Environment Agency permitting decisions

Bespoke permit

We have decided to grant the permit for Calvert Landfill (Pit 6) operated by FCC Waste Services (UK) Limited. The permit also includes a facility for the treatment of incinerator bottom ash.

The permit number is EPR/BP3637AF

Figure 6 Schematic Representation of Pit 5/6 Separation Bund

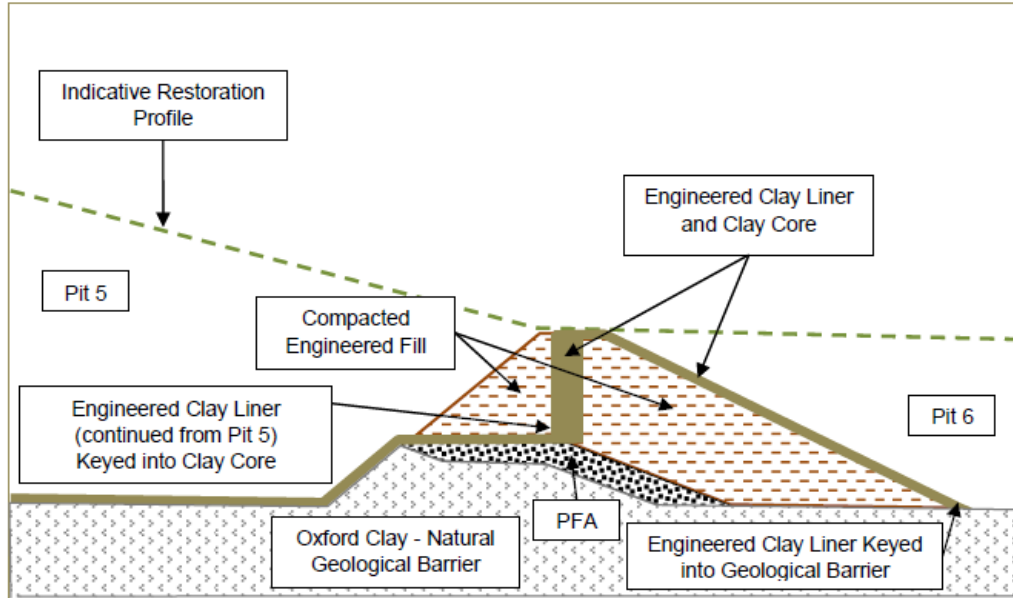
Information of the design of the bund presented by the Operator, states it consists of various materials and waste, as described in the response to the S5N of 25-02-16 Figure 6 (detailed below) which is a schematic representation of the bund.

Importantly it contains an artificial geological barrier/ artificial sealing liner clay layer on either side slope. It also includes a partial clay core but underneath that there is a significant layer of PFA that straddles both sides of the permit boundary between Pits 5 and 6.

Assessment of the effects of effective porosity and permeability variations in the components of the bund, and the effects that such variations could have on flow of leachate and diffusion of substances through the bund, were not provided. Instead the operator has relied on an assessment of deformations in the bund to assert that there will be no significant flow from one side to the other. That assessment does not address the influence of the permeability of the PFA layer which is likely to have a markedly higher permeability than the other engineered components of the bund.

In the UK as a general rule bituminous coals are burnt with a few exceptions where anthracitic coals are used, meaning that permeability of the PFA at around $1 \times 10^{-7} \text{ m/s}$ in the bund is likely to be around several orders of magnitude greater than $1 \times 10^{-9} \text{ m/s}$ which was used by the Operator to calculate travel time through the clay part of the bund. The permeability of the PFA was not taken into account in the operator's HRA or SRA (see page 21 of the response dated 25-2-16 to the S5N). The influence of the PFA layer as a primary pathway for leachate to migrate from the Pit 5 side of the bund to the Pit 6 side, or vice versa, in this respect was not considered by the operator.

As a check on the effect of the PFA layer and its' likely permeability on the transmission of leachate through the bund from one side of the permit boundary to the other, we have taken the equations used by the Operator and input data presented on page 21 of the operator's response dated 25-02-16 to the S5N. However we used an average permeability of $1 \times 10^{-7} \text{ m/s}$ for the PFA, as presented in the data above. We have assumed in this calculation that once the leachate goes through the bund sidewall clay barrier, it would enter the PFA layer where it would travel through it rapidly in a direction from high head to low head. If we use the Operator's method of calculating travel time through the PFA layer in the bund and assume a PFA permeability of $1 \times 10^{-7} \text{ m/s}$ and a porosity of 0.2 is used in the equation the resulting travel time is of the order of several years through the PFA straddling both sides of the Permit boundary. This is two orders of magnitude less than the Operator's prediction which relates to the clay part of the bund only. Even taking into account the presence of the side slope geological barrier and engineered fill over the PFA layer on the Pit 6 side of the bund, once leachate enters the PFA layer it would flow through the PFA layer from the Pit 6 side of its' permit boundary to beyond its' boundary on the other side within the Pit 5 boundary.

Also, should there be a significant imbalance of leachate heads over a prolonged period of time there is the possibility that pore pressures in the core of the bund, particularly in the PFA layer, could build up. This could lead to deformation of the clay core and engineered geological barrier on the side slopes of the bund resulting in an increase in permeability and flow-through and in a loss of separation. By maintaining balanced leachate heads either side of the bund at a level below the groundwater piezometric head there will be no discernible flow through the bund.

Leachate heads in Pit 5 and in Pit 6 need to be balanced in cells either side of the permit boundaries and below the groundwater piezometric head. This is to prevent a driving head in one direction or the other through the bund, to ensure effective separation of the permitted landfills. This will also prevent any outward flow of leachate from either pit 5 or pit 6. In order to maintain leachate heads at these levels, a leachate collection system is required in Pit 6.

- management of leachate heads in the separate permitted landfills either side of the bund at a level below groundwater piezometric heads; this is to prevent a driving head from one side of the bund to the other through the PFA layer in the bund
